RAINBOW CHILD CARE JSP16-43

Consideration at the request of 814 Development LLC for approval of Preliminary Site Plan and Storm water Management Plan approval. The subject property is located in Section 17 of the City of Novi north of Grand River Avenue and west of Beck Road in existing West Market Square. The applicant is proposing to construct a single story daycare building, consisting of 10,782 square foot office space, outdoor recreation area which includes three play structures and associate site improvements.

PLANNING REVIEW

Review Date: September 19, 2016
Review Type: Preliminary Site Plan
Project Name: **RAINBOW CHILD CARE**
Plan Date: August 26, 2016
Prepared by: Sri Komaragiri, Planner
E-mail: skomaragiri@cityofnovi.org; **Phone:** (248) 735-5607

Job No.: _____ Sheet: **SP-2**

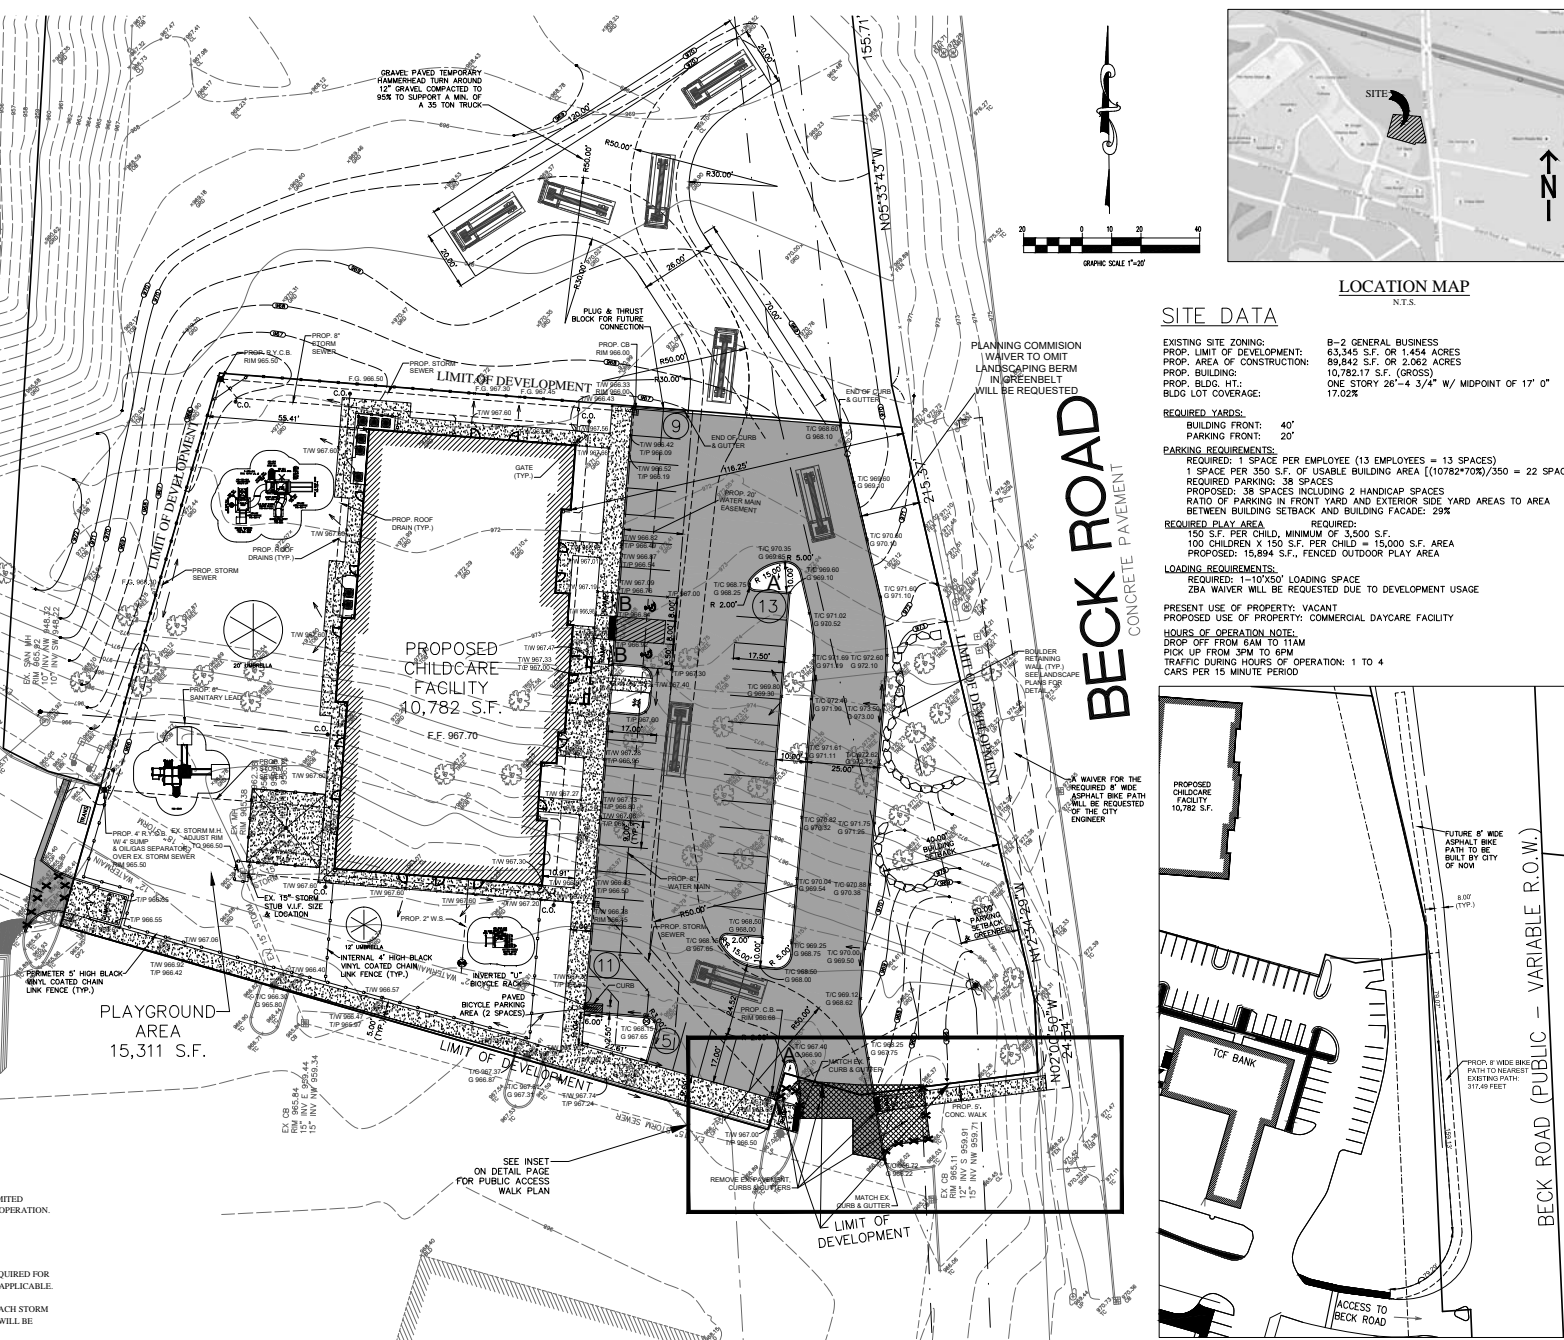
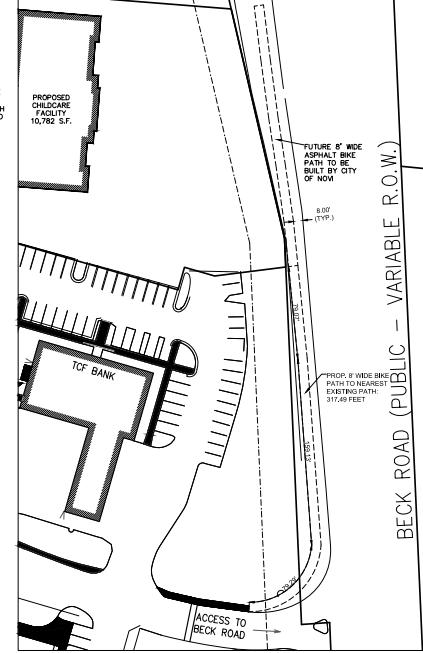
- e. The Signage Schedule on sheet SP-2 should include the van accessibility signs.

- e. The Signage Schedule on sheet SP-2 should include the van accessibility signs.
- Plans will be revised with the Final Site Plan submittal

Job No.: Sheet: LS-2

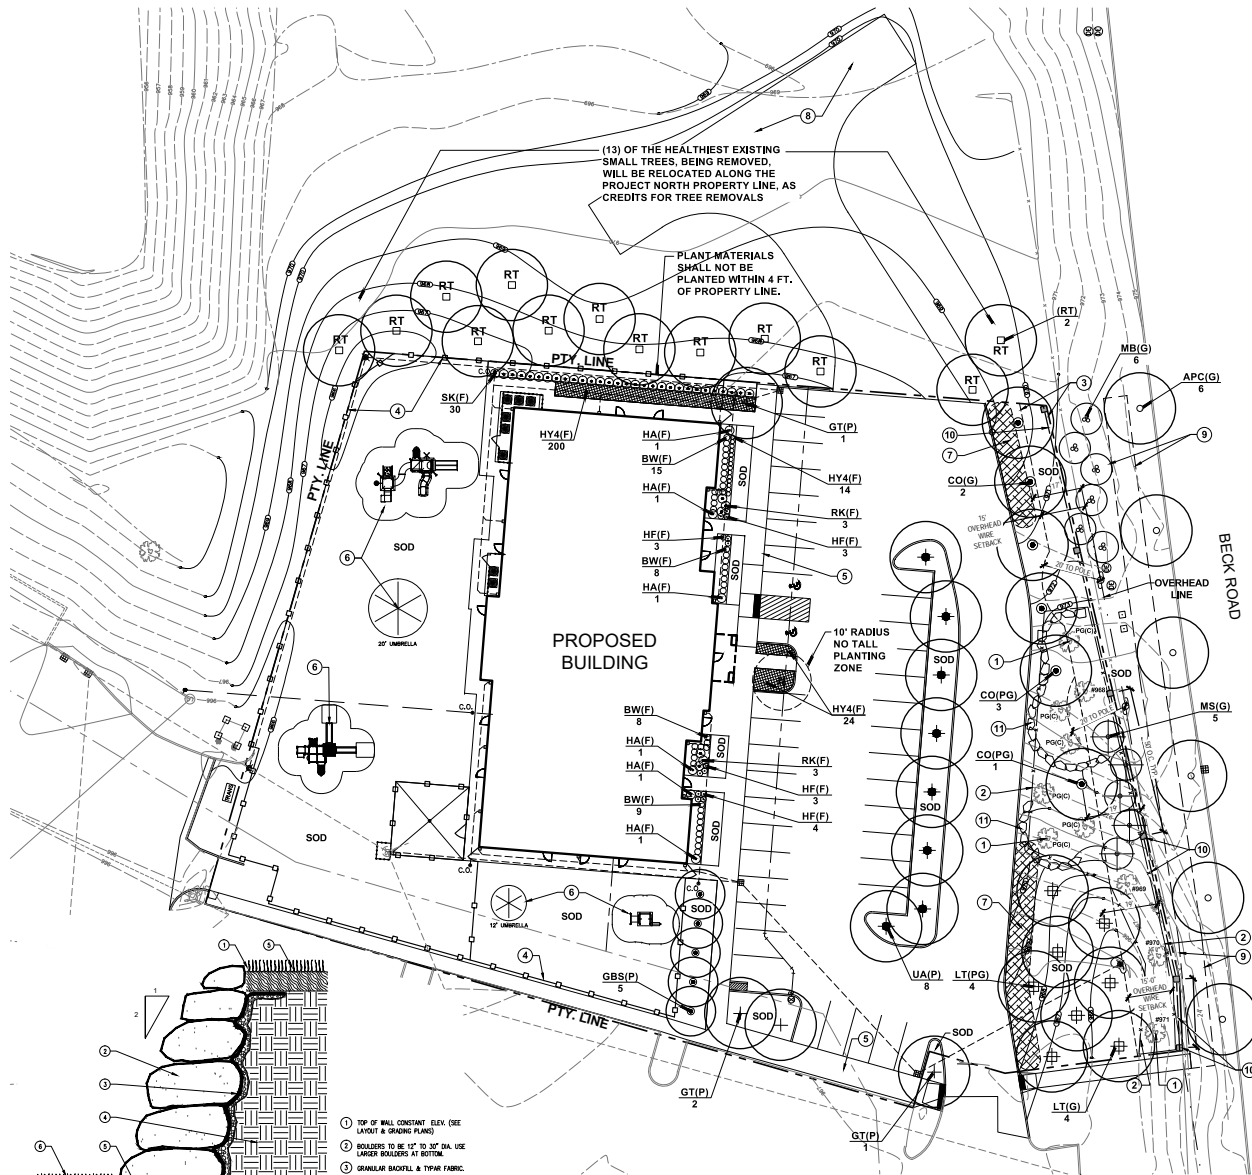
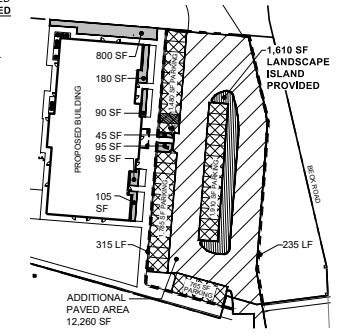
Please add a table to Sheet LS-1 with all requested waivers, including the number of trees or landscape area not provided.

1. Six trees are provided along 225lf of frontage as required.
2. **Please change the species from Norway Maple to a non-invasive one with a mature canopy width of at least twenty feet.**

1. Based on the 550 lf of perimeter, 15 canopy trees are required. 13 canopy trees, including 5 existing trees, are proposed.
2. **Please move all perimeter canopy trees to within 15 feet of the curb.**
3. **A landscape waiver is required to not provide all of the required trees, but it will be supported by staff due to the limited room available, and good effort toward landscaping the site fully.**

1. 71% of the front of the building visible from Beck Road is landscaped, exceeding the requirement.
2. **Based on the building perimeter, 3760 square feet of foundation landscaping is required.**
3. **Only 1410 sf is provided because much of the building is surrounded by play areas.**
4. **Additional foundation landscaping area can be achieved by adding additional shrubs, grasses or perennials on the long interior island. The area with additional plantings can be counted toward the requirement. A landscape waiver is required to locate foundation landscaping away from the building, but would be supported by staff.**
